Access Compliance Report

Public Rights-of-Way (Curb Ramps)

Intersection ID: 25897	Main Street: CASTLEKEEP_RD	Cross Street: TIMBERCREST_CR	Location: SE
ADA ID: 93E2787F1491	Ramp Type: Directional1	Initial Pass/Fail: Fail	Overall Compliance: No
		Severity Score: 25

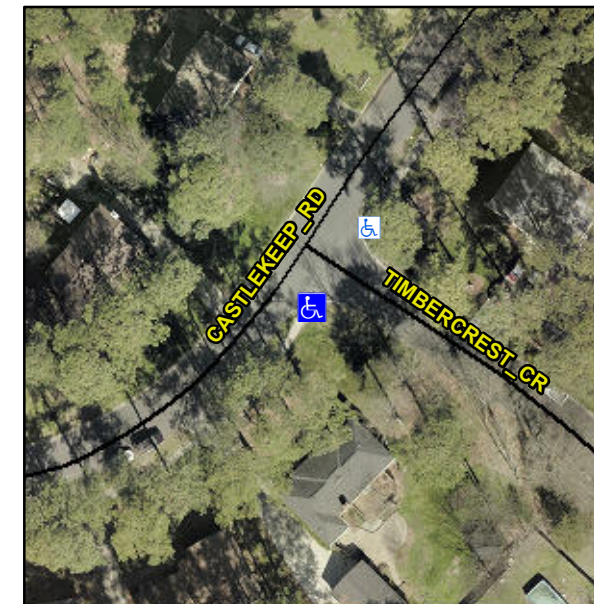
R304.2.2, R304.5.3

Compliance	Description	Data	Compliance	Description	Data
N/A	Ramp Length (in)	86.0	N/A	Grade Break?	N/A
Yes	Ramp Width (in)	59.0	N/A	Grade Break Slope (%)	0.0
No	Ramp Slope (%)	10.8	N/A	Grade Break XSlope (%)	0.0
No	Ramp XSlope (%)	5.1			
N/A	Flare Type LT	N/A	N/A	Flare Type RT	N/A
N/A	Flare Slope LT (%)	N/A	N/A	Flare Slope RT (%)	0.0
N/A	Flare Traversable LT?	N/A	N/A	Flare Traversable RT?	N/A
N/A	Landing Length (in)	0.0	N/A	DWS Provided?	N/A
N/A	Landing Width (in)	0.0	N/A	DWS Contrast?	N/A
N/A	Landing Slope (%)	0.0	N/A	DWS Length (in)	N/A
N/A	Landing X Slope (%)	0.0	N/A	DWS Full Width?	N/A
N/A	Landing Curb? (Y/N)	N/A	N/A	DWS Offset LT (in)	N/A
N/A	Shared Landing?	N/A	N/A	DWS Offset RT (in)	N/A
N/A	Gutter Ponding?	0.0	N/A	Gutter Slope (%)	N/A
N/A	Gutter Lip Ht (in)	0.0	N/A	Gutter X Slope (%)	N/A
N/A	Painted X Walk1?	No		Road Slope (%)	2.2
	X Walk 1 Direction	To N		Road X Slope (%)	9.0
	X Walk 1 Width (in)	N/A		Clear Space?	N/A

Remove & Replace Entire Ramp.
